**MAINE TURNPIKE AUTHORITY**

**ADDENDUM NO. 2**

**CONTRACT 2015.06**

**INTERCHANGE 36 SACO TOLL PLAZA LANE ADDITION (MM 36.0) & VARIABLE  
MESSAGE SIGN RELOCATION (MM 28.3)**

INTERCHANGE 36  
SACO TOLL PLAZA LANE ADDITION  
GUARDRAIL DETAILS  
(1 OF 2)

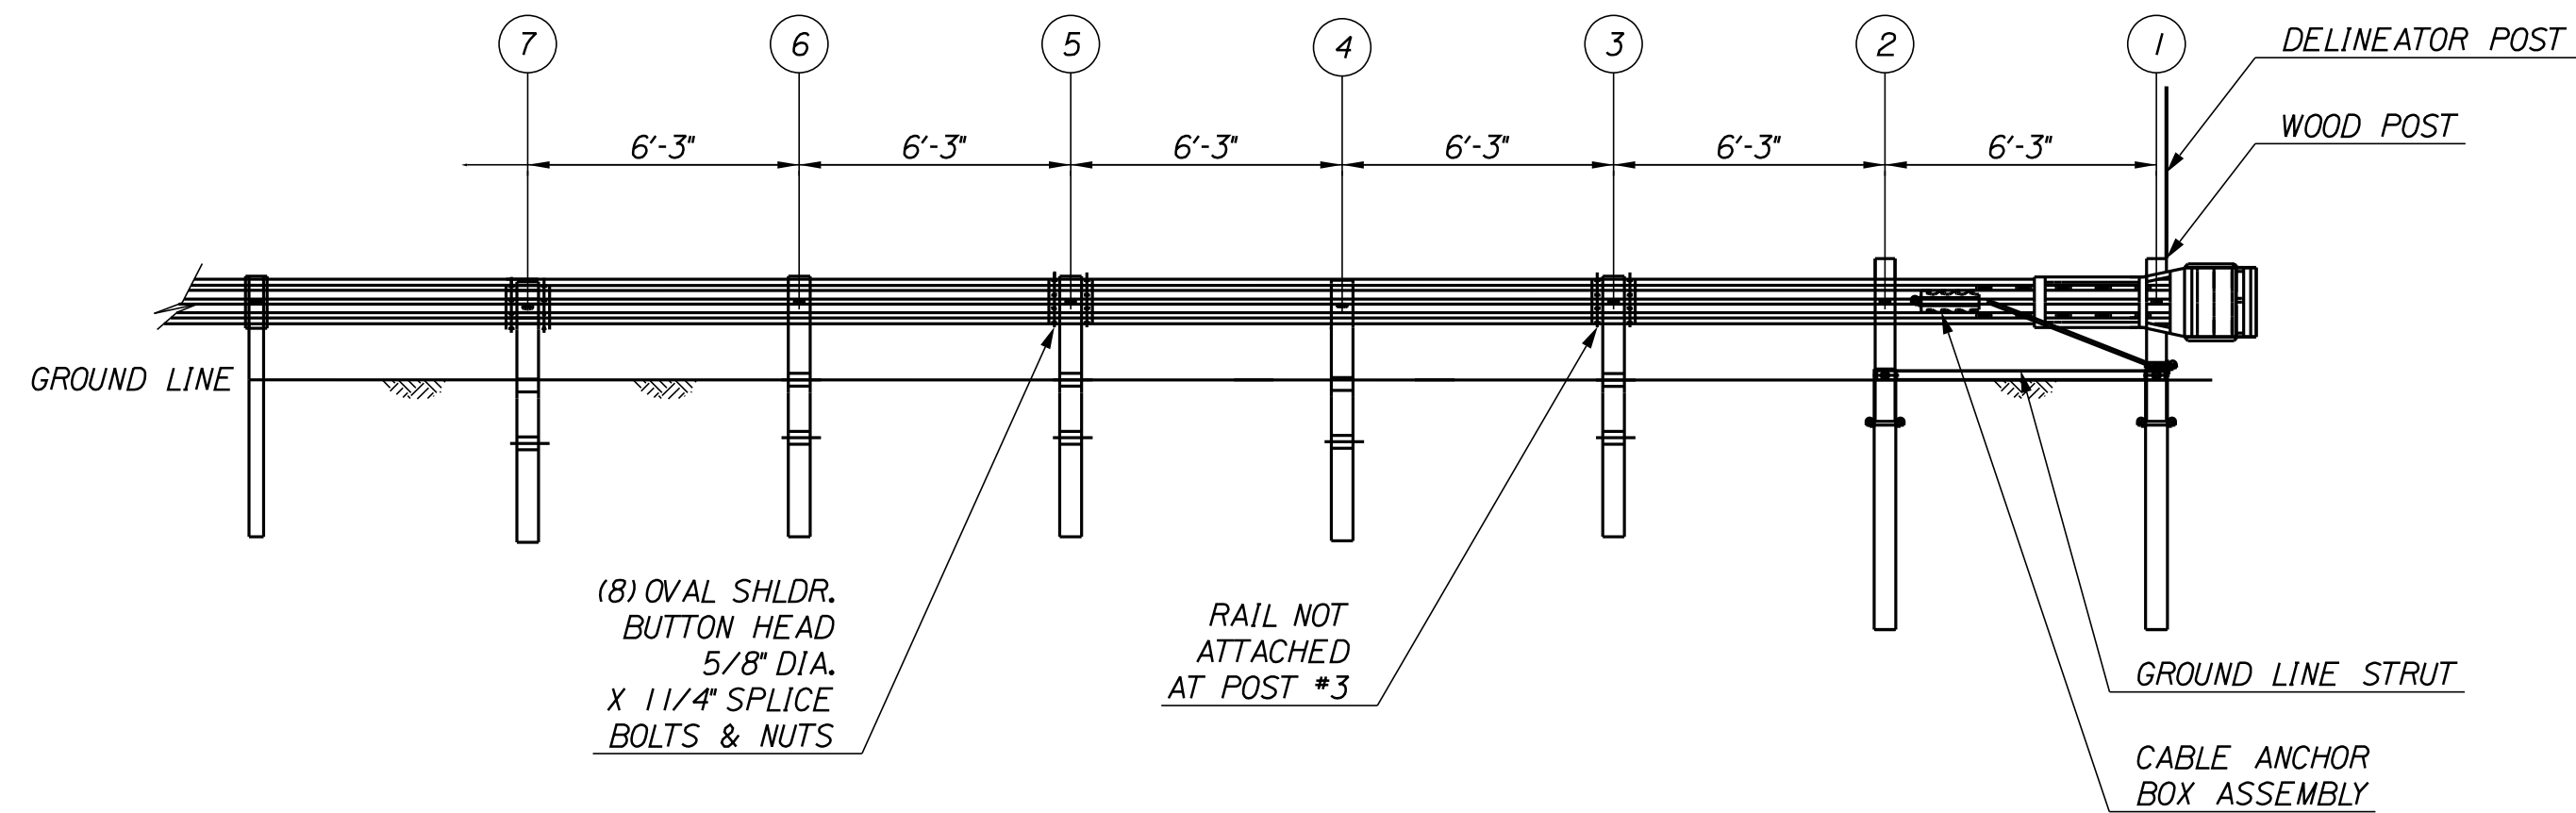
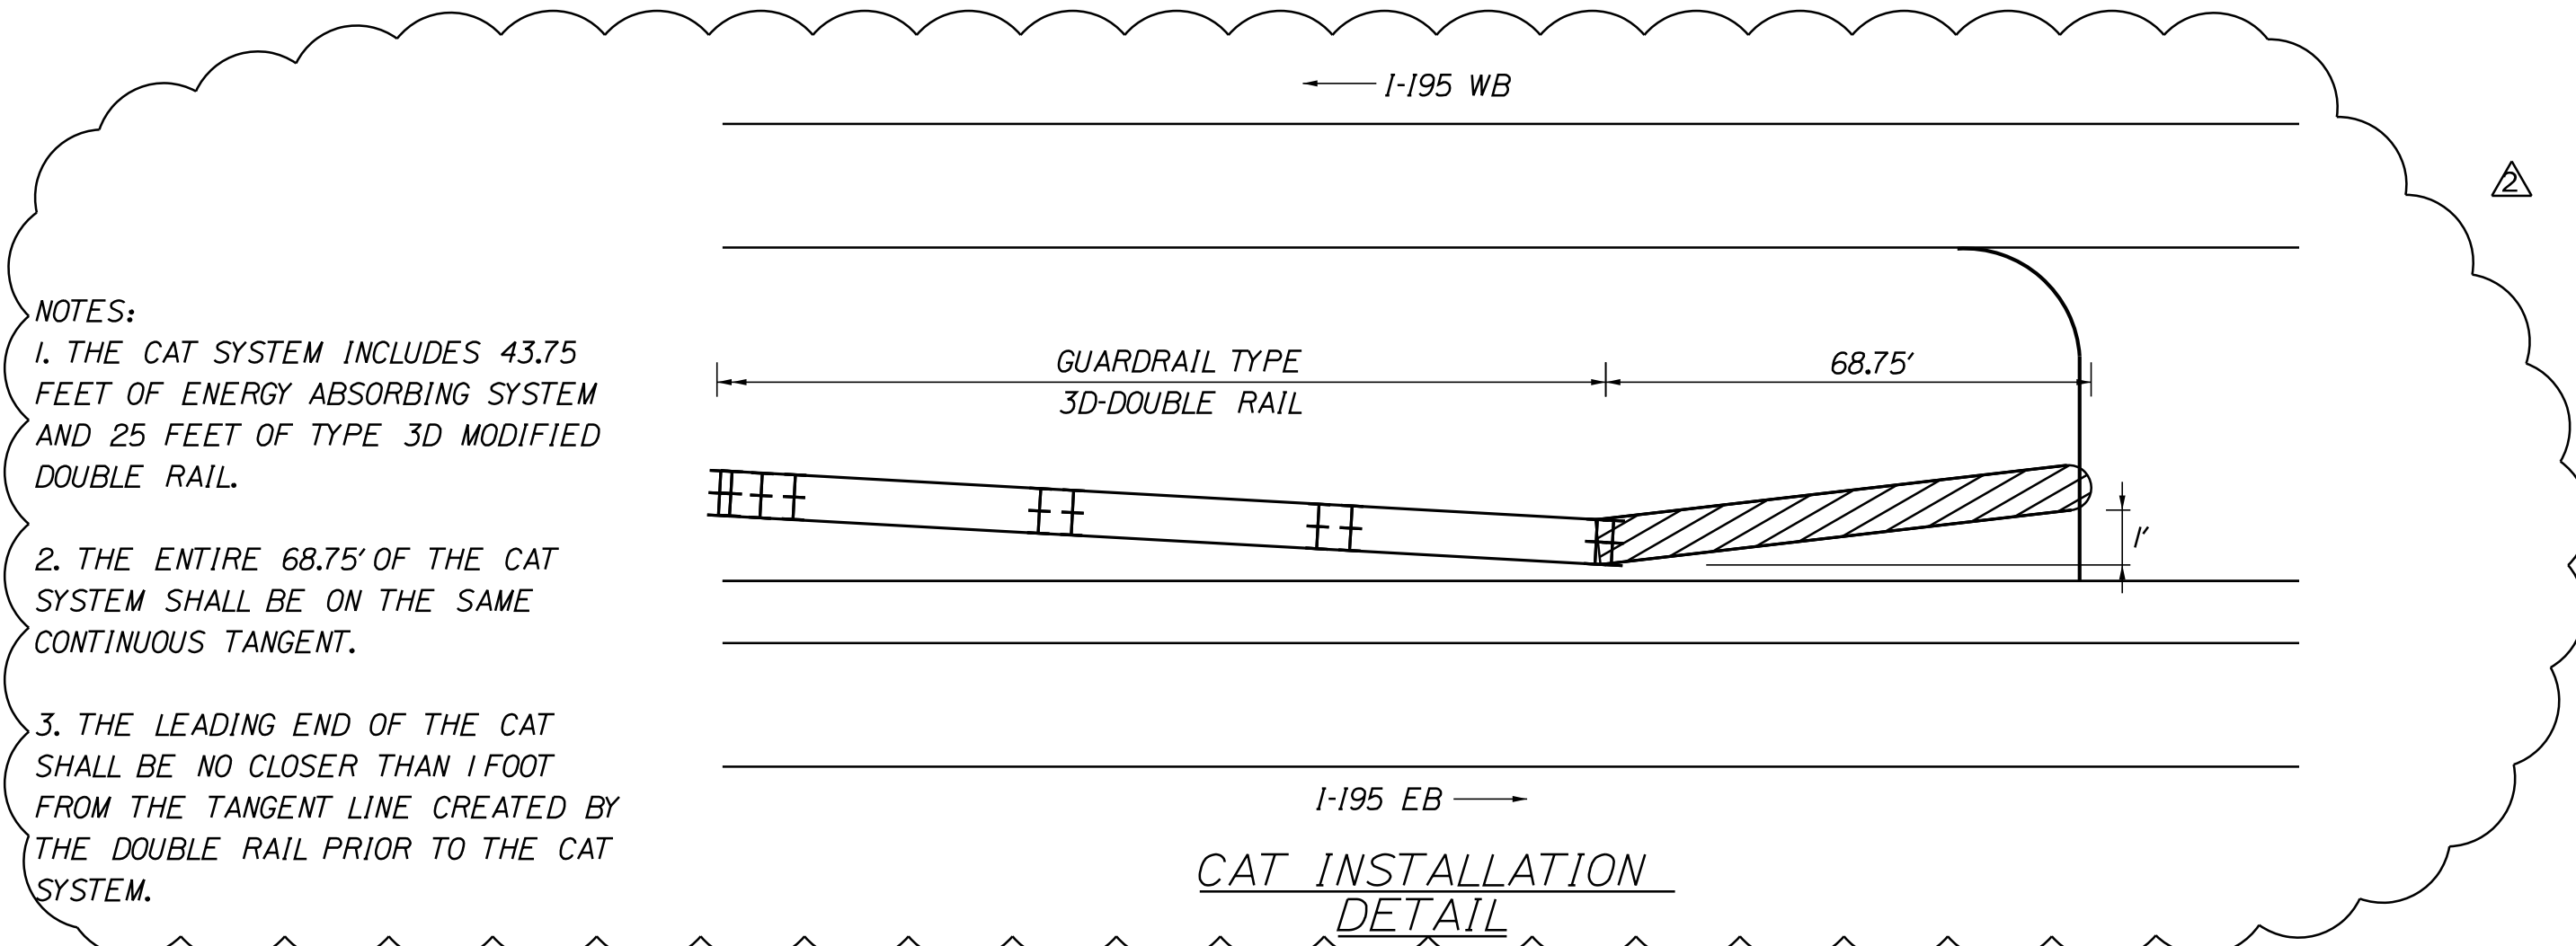
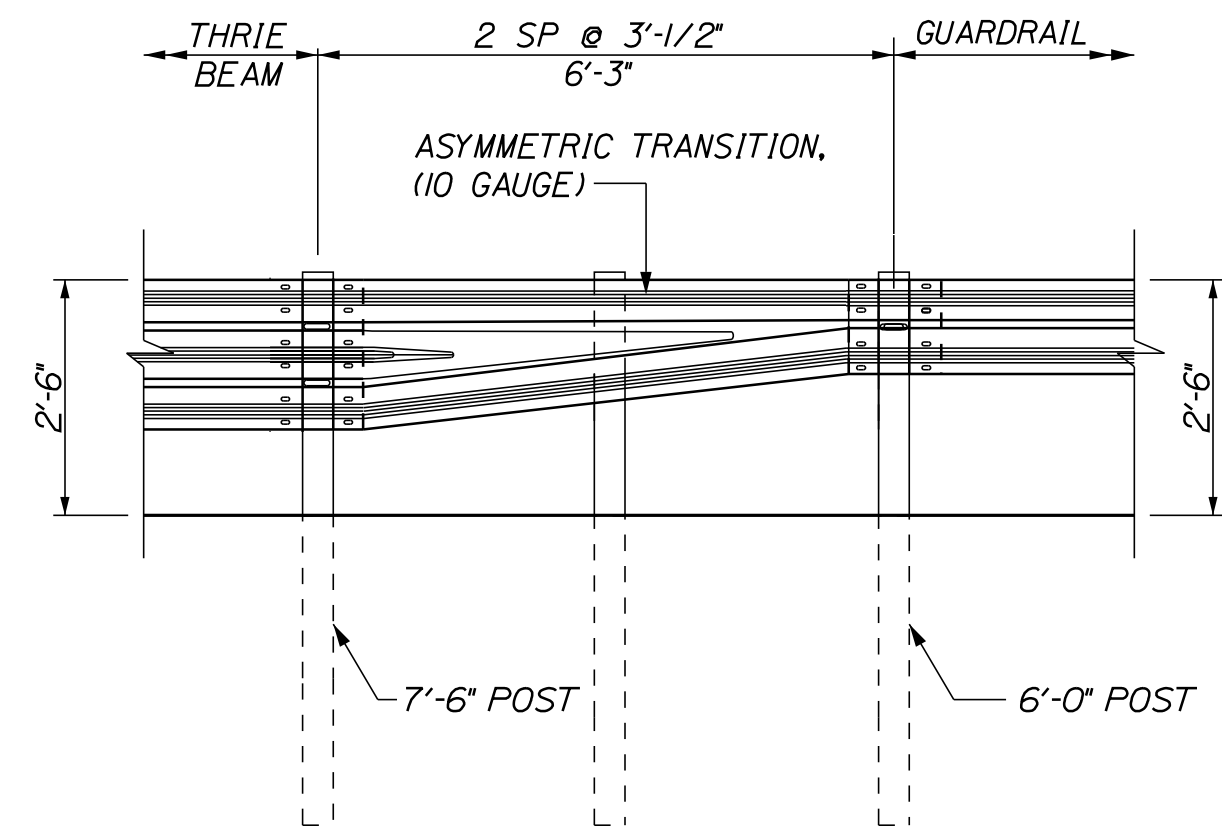
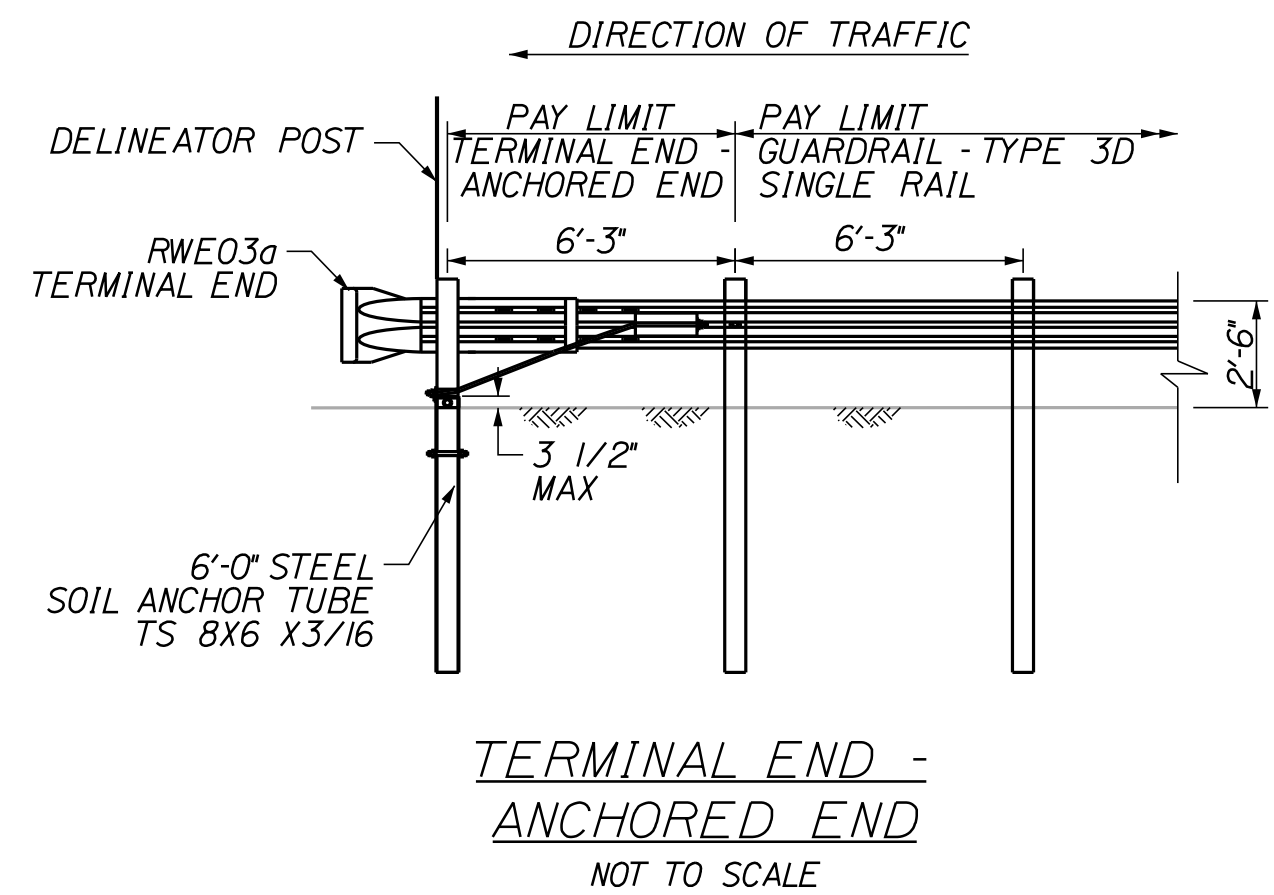
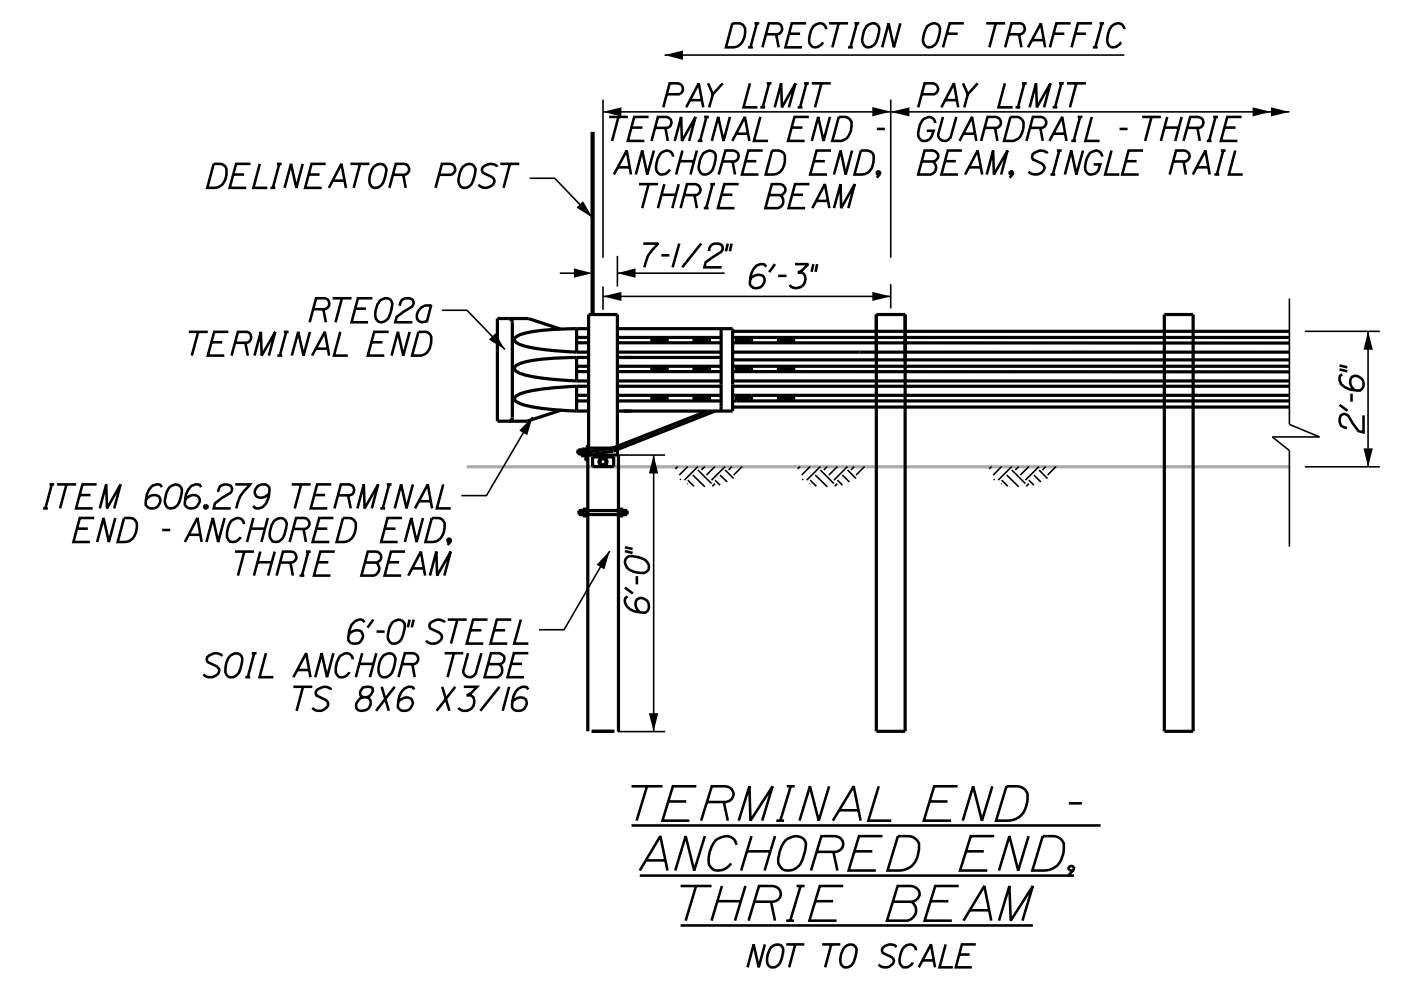
**ADDED** Item 527.301 Energy Absorbing System (CAT): 1 EA

In the Contract Documents, **ADD** Part 2-Special Provisions, Section 527 ENERGY ABSORBING UNIT (Energy Absorbing System (CAT)).

- NOTES:
1. THE CAT SYSTEM INCLUDES 43.75 FEET OF ENERGY ABSORBING SYSTEM AND 25 FEET OF TYPE 3D MODIFIED DOUBLE RAIL.
  2. THE ENTIRE 68.75' OF THE CAT SYSTEM SHALL BE ON THE SAME CONTINUOUS TANGENT.
  3. THE LEADING END OF THE CAT SHALL BE NO CLOSER THAN 1 FOOT FROM THE TANGENT LINE CREATED BY THE DOUBLE RAIL PRIOR TO THE CAT SYSTEM.
